CENTERVILLE CITY PLANNING COMMISSION AGENDA

| 7:10 | 2. | PUBLIC HEARING THE PASTURE BUSINESS PARK 1275 NORTH 1300 WEST

ZONING: SHORELANDS COMMERCE PARK (SCP) DISTRICT

APPLICATION: TABLED FROM FEBRUARY 12, 2014 MEETING
CONCEPTUAL SITE PLAN (AMENDMENT)

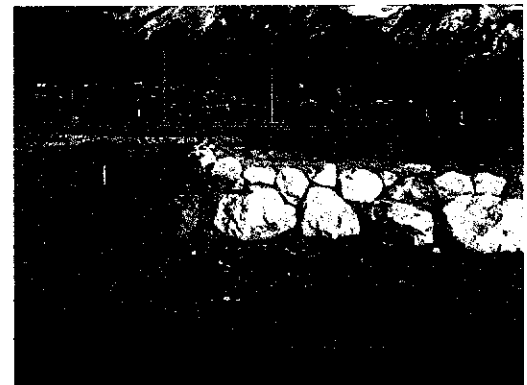
- **Staff Concern:** Within Chapter 12-68, Shorelands Commerce Park District Design Standards, it is clear to how this wall should be designed. It first states in Section 12-68-040(e), that man-made accents are allowed such as terraced walls with limited height. This gives the impression that solid long walls are not the ideal choice of retention. In Section 12-68-050(c)(1), it states that structures and exterior spaces blend into the natural contours of the site. Furthermore, in this same section, it also states that man-made contouring match natural contouring, and to not start and stop with abrupt edges. Finally, in Section 12-68-050(d)(10), it requires walls and all landscaping features to be used in a natural appearing manner.

Staff does not see the current wall meeting this requirement. However, the wall in its similar construction was approved by the Planning Commission on April 25, 2012, with the wall being broken up by the timber landscaping design feature. Therefore, in order for the applicant to meet the intent of the original approval and the requirements found in Chapter 12-68 of the Zoning Ordinance, staff is requesting the timber accents be placed below the wall and as close to the wall as possible. In addition, the Shorelands Commerce Park (SCP) approved vegetation needs to be planted around the timbers in order to give the appearance from the street that these spaces are broken up. Staff also requests that these features and plantings have a random and not a formalized appearance, therefore meeting the Ordinance requirement of a natural and complementary shoreland environment. Finally, the corners of the wall as pictured above should be altered as to give variety in height and spacing. The corners should also have a slope of no more than

45 degrees, to allow for vegetation. This landscaping detail will need to be submitted as part of the final site plan (amendment).

1. The applicant shall submit an amended final site plan, meeting the standards found in Section 12-21-110(e) of the Ordinance.
2. The applicant shall address the timber concept and indicate location and height over the rock wall and plantings appropriate to the Shorelands Commerce Park Design.

3. The timbers and landscaping shall be placed as to appear random and natural, rather than formalized.
4. The applicant shall address the corners of the rock wall with a 45 degree angle of wall, where possible, and breaking up the mass of the wall to allow for more variety of vegetation/plantings. These areas shall have appropriate Shorelands Commerce Park vegetation.

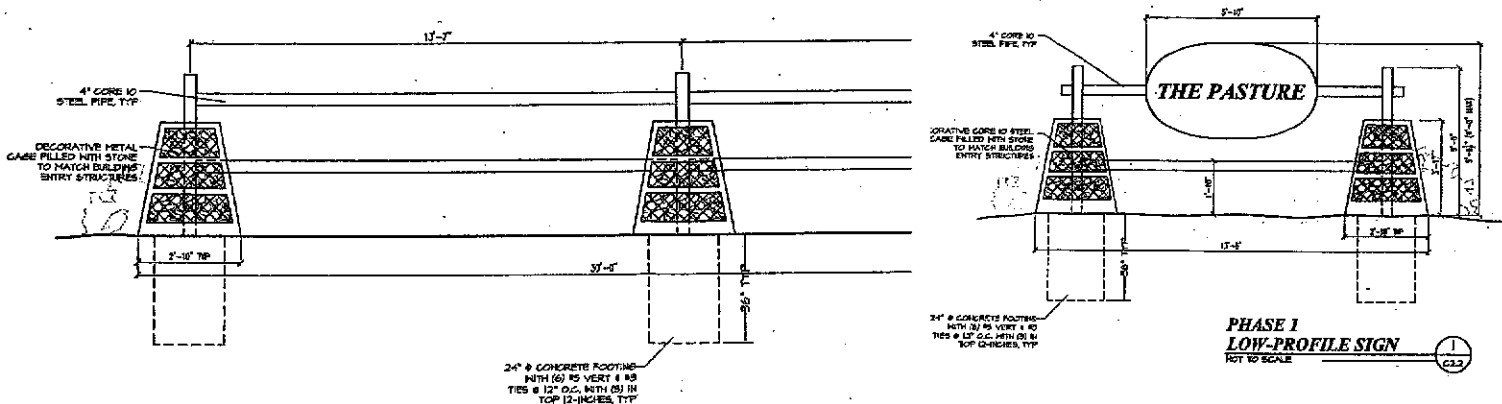
The applicant also desires to modify the bridge design that would be less costly in order to create the same entryway features. The applicants new design is much less formal and utilizes the concept of decorative metal cages filled with stone that matches the building entry structures. These cages act as the post to the bridge feature with connecting steel pipe from each decorative metal cage. The cage and the pipe are constructed with Core 10 Steel, which over time will have a natural rust color. This type of steel is often used for electrical poles and guardrails that are meant to blend into the environment.

- **Staff Concern:** Although supportive of the decorative cage idea, this concept as with the original, expands the space required on the bridge. The City Engineer has stated that the bridge is too narrow and will need to be widened in order to accommodate the pillar structures and two-way traffic. This will require the driveway and drive-isle be measured at 25 feet, with additional footage for space to place the decorative cages. This description will need to be indicated on the final site plan. Since all three driveways will need to accommodate two-way traffic, they will all be required to meet this standard.

The following is a new design for the bridge feature and front entryway sign feature. Staff believes the front monument sign is still integrated into the landscape design and matches the other site feature.
